LAND USE APPLICATION SUMMARY

Property Location: 1407, 1411, 1413, and 1423 45th Ave N, 4414 Humboldt Ave N
Project Name: Webber Park Library
Prepared By: Joe Giant, City Planner, (612) 673-3489
Applicant: Hennepin County
Project Contact: J. Michael Noonan
Request: To construct a new public library.
Required Applications:

Design Development
GRADING AND DRAINAGE PLAN

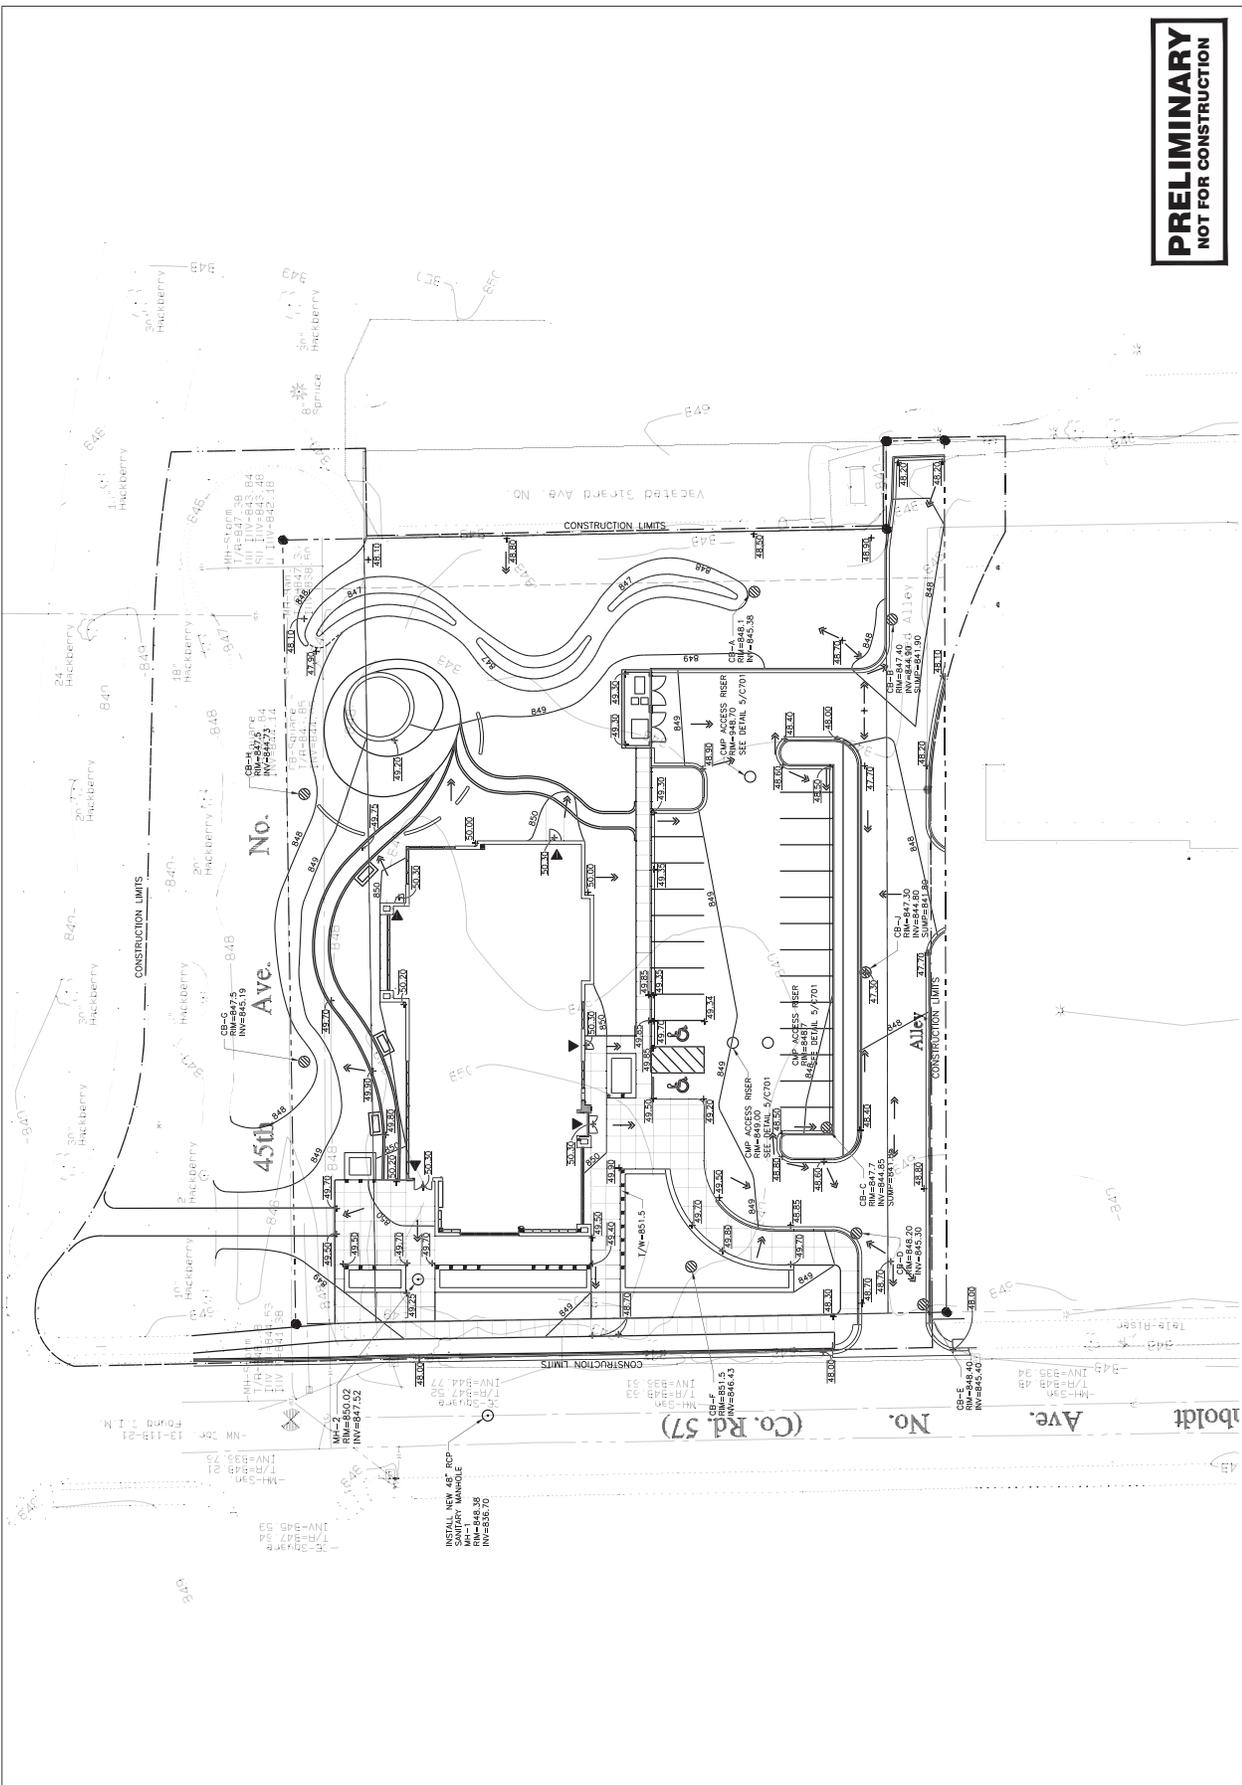
- Surface Drainage: Please include, on the grading plan, proposed contour lines in sufficient detail to depict the drainage patterns of the site.
- Utility Connections: Please provide justification for the sizing of the proposed 12" sanitary sewer connection. The size of the connection should be minimized as much as possible, while providing sufficient capacity.

Project: Webber Park Library Drawing Number: A401
Client: Clark Construction Date: 11/11/11
Designer: Matthew Lind Scale: AS SHOWN
Checkered: _____
Checked: _____
Approved: _____
Contractor: _____
Copyright © 2011 LSE Architects, Inc.

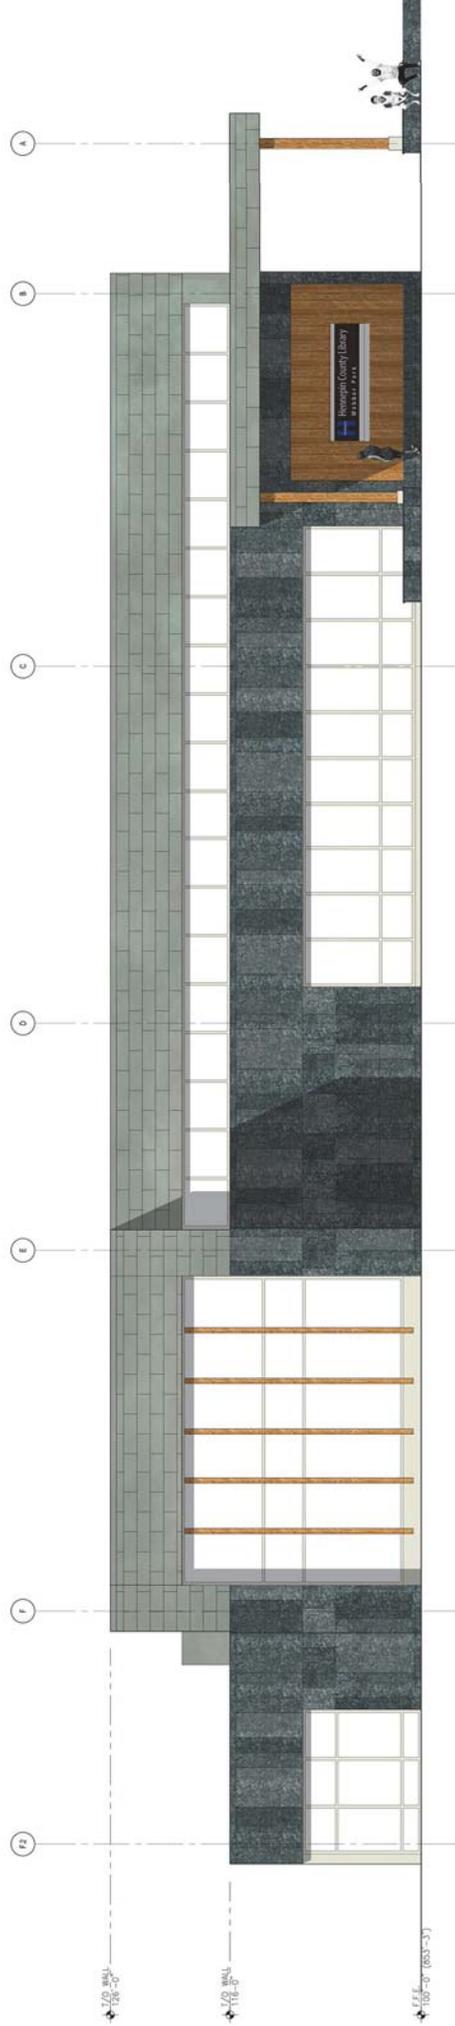
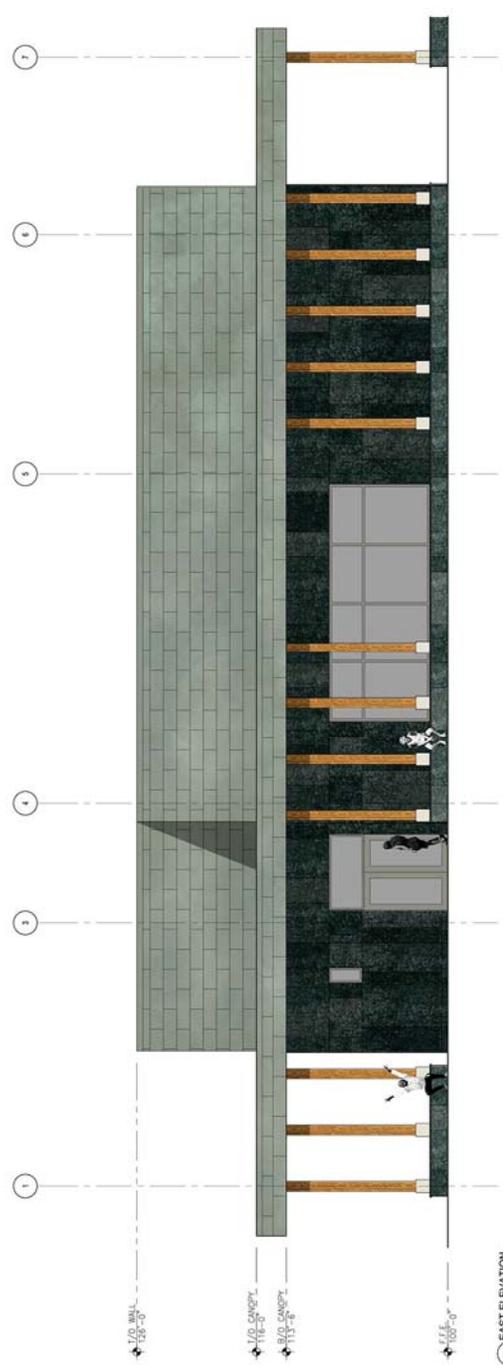
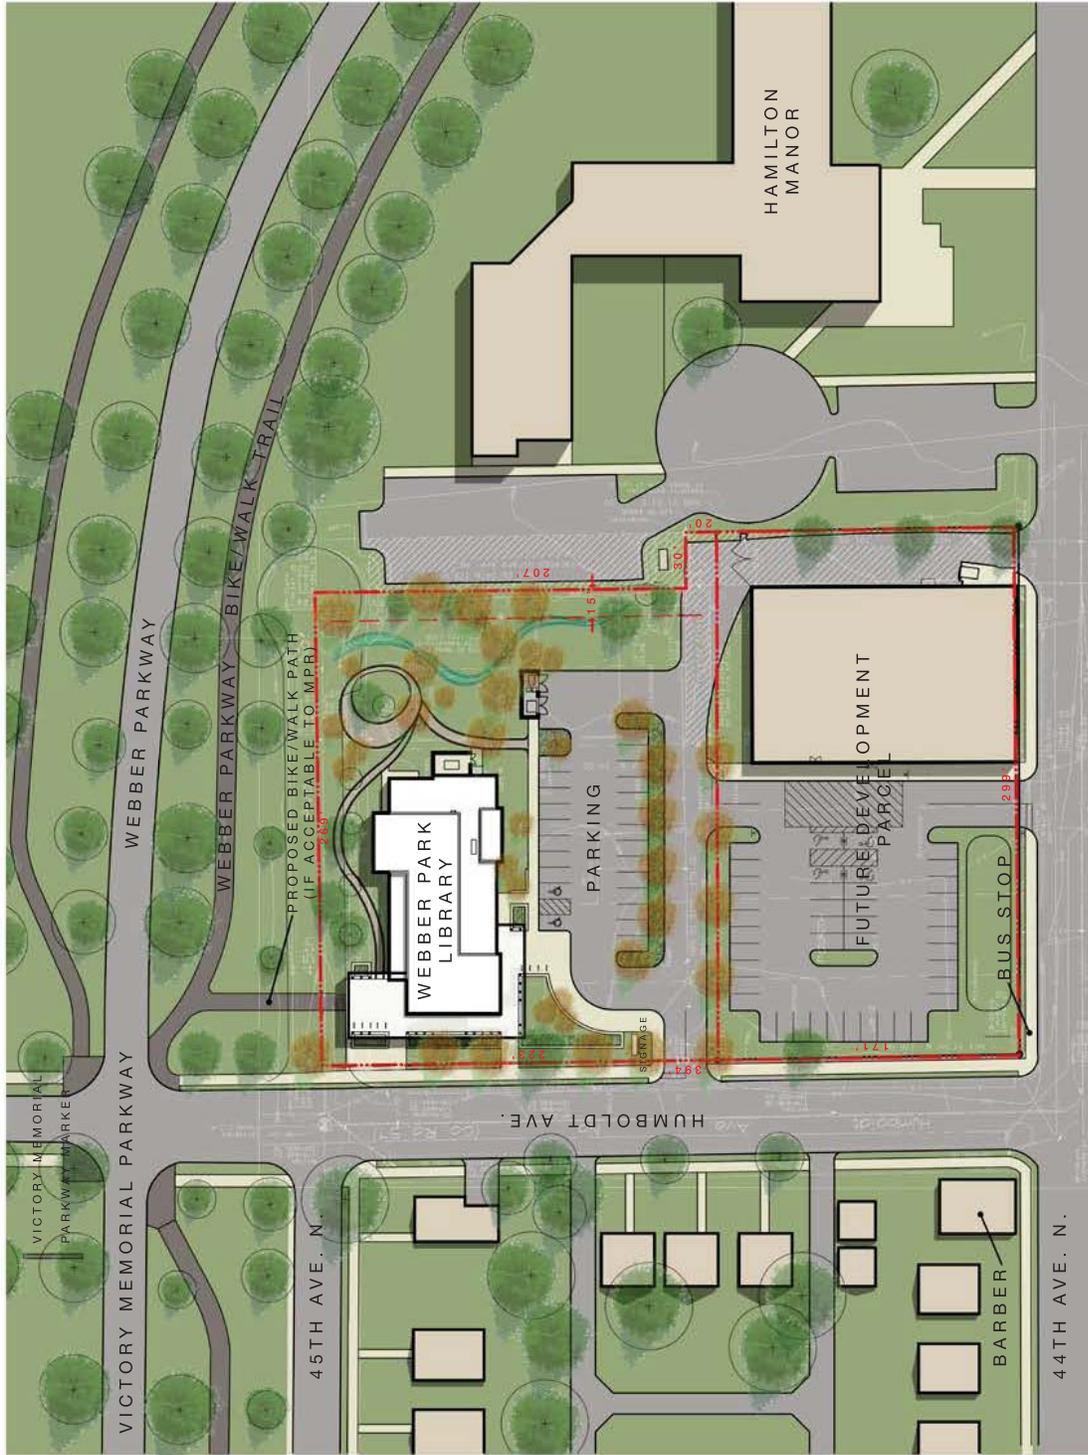
- **Windows along Humboldt Ave N.** Building walls facing a public street or on site parking area must be composed of at least 30% windows between 2 and 10 feet above the adjacent grade. The proposed building elevation contains 27% windows along Humboldt Ave. Staff recognizes that the shortcoming in window area is somewhat mitigated by the provision of outdoor activity space under the canopy along this building façade and by ample plantings in raised planting beds between the building wall and the sidewalk. However, these mitigating factors do not sufficiently address CPTED principles relating to natural surveillance and eyes on the street. Meeting the minimum window requirement in order to promote these principles is a compelling purpose. Therefore, staff recommends that alternative compliance not be granted and that the minimum window requirement be met.

- **Windows on south façade.** The south façade contains 28% windows rather than the minimum 30%. Staff finds that the shortcoming in window area is mitigated by the ample placement of windows on non-primary building walls and the provision of amenities between the building wall and the parking lot. The south façade features seats built into the structure, a plaza, and bicycle parking. The southeast quadrant of the building contains all of the mechanical equipment. Placing windows in this location would provide little benefit. The other portions of the building are open to the public and contain ample windows.

6. The applicant shall provide additional glazing on the west and south elevations to achieve a minimum of 30 percent on each elevation, in compliance with Section 530.120 of the zoning code.
